Permit Application Review Report
Date: 3/19/2025

Project Name: City of Blaine 2025 Southwest Area Street Reconstruction Project

Project PAN: P-25-004

Figure 2: Site Plan

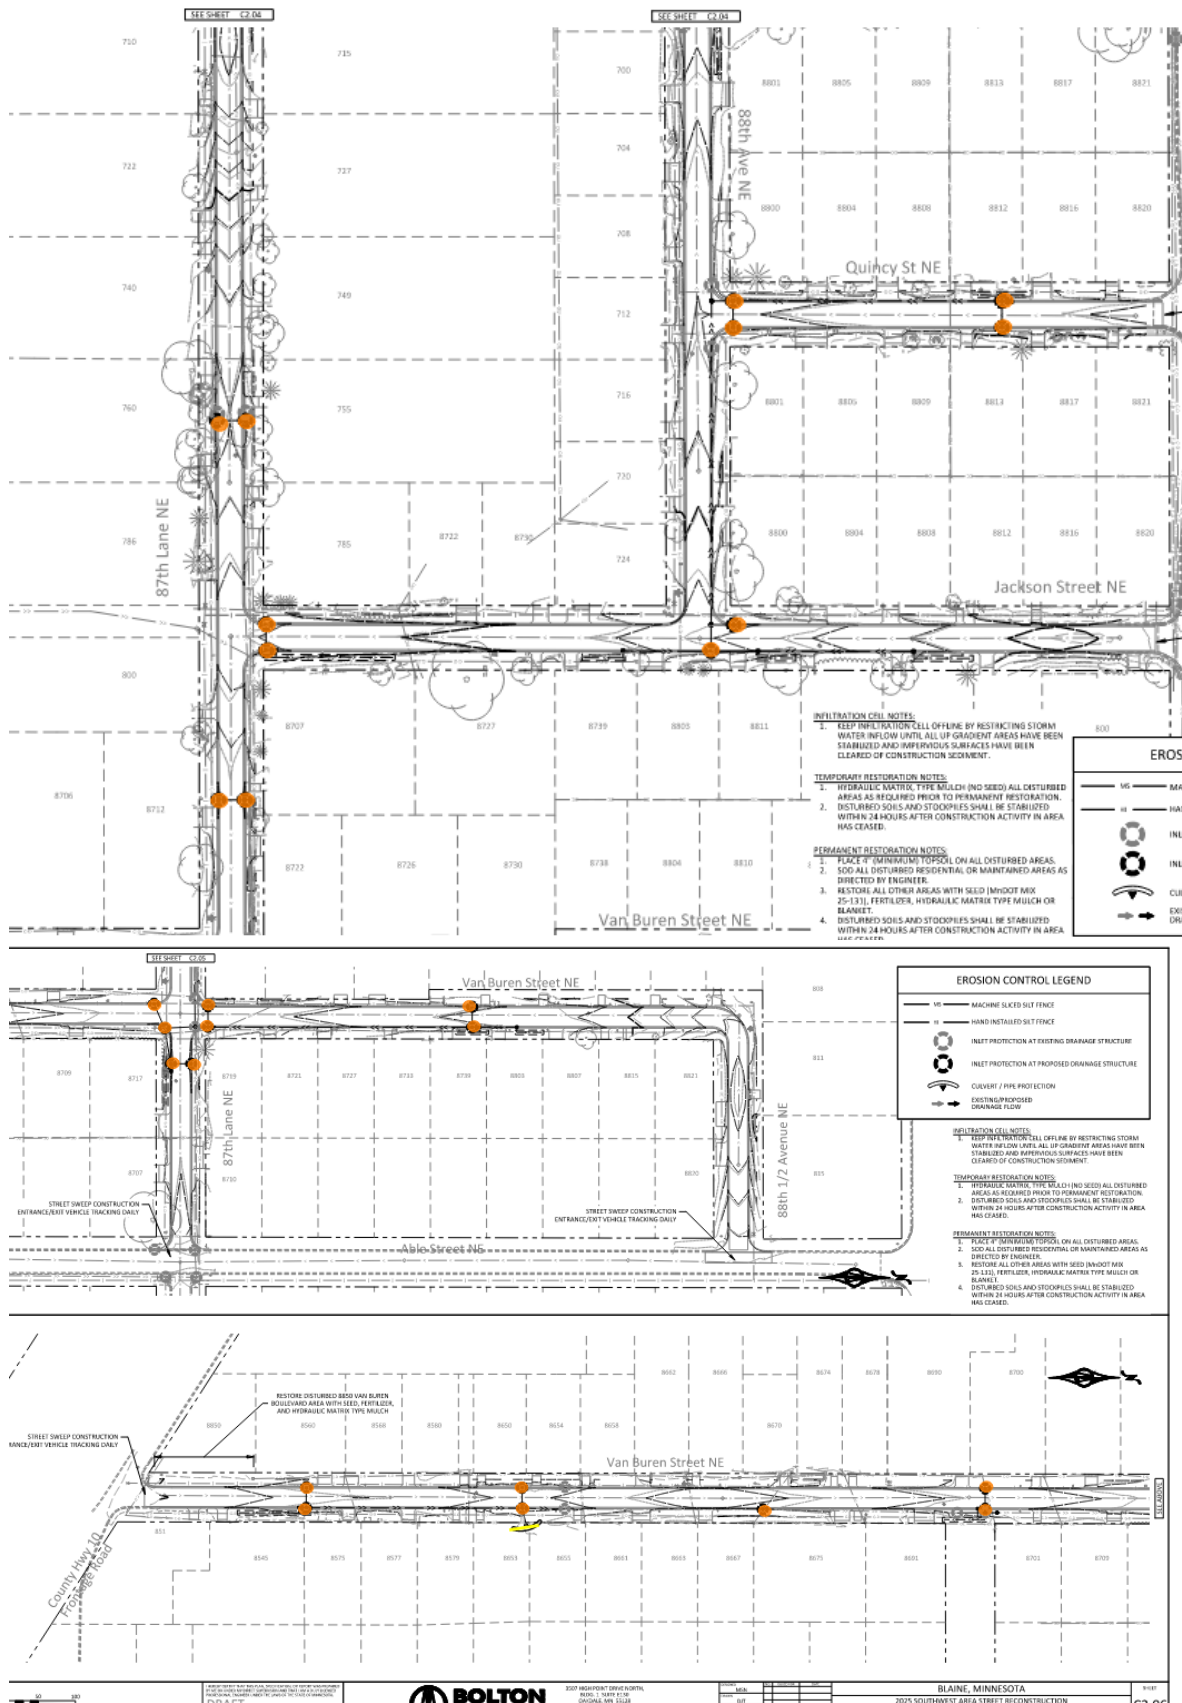
Description: The City of Blaine is proposing the reconstruction of numerous city streets and the construction of new stormwater treatment features. The project will disturb 9.49 acres and slightly reduce the overall impervious to 6.84 acres. The area drains to Springbrook Creek. The relevant water resource concerns are stormwater treatment and erosion and sediment control, which correspond to District Rules 3 and 4. See attached Figure 1: Project Location and Figure 2: Site Plan.
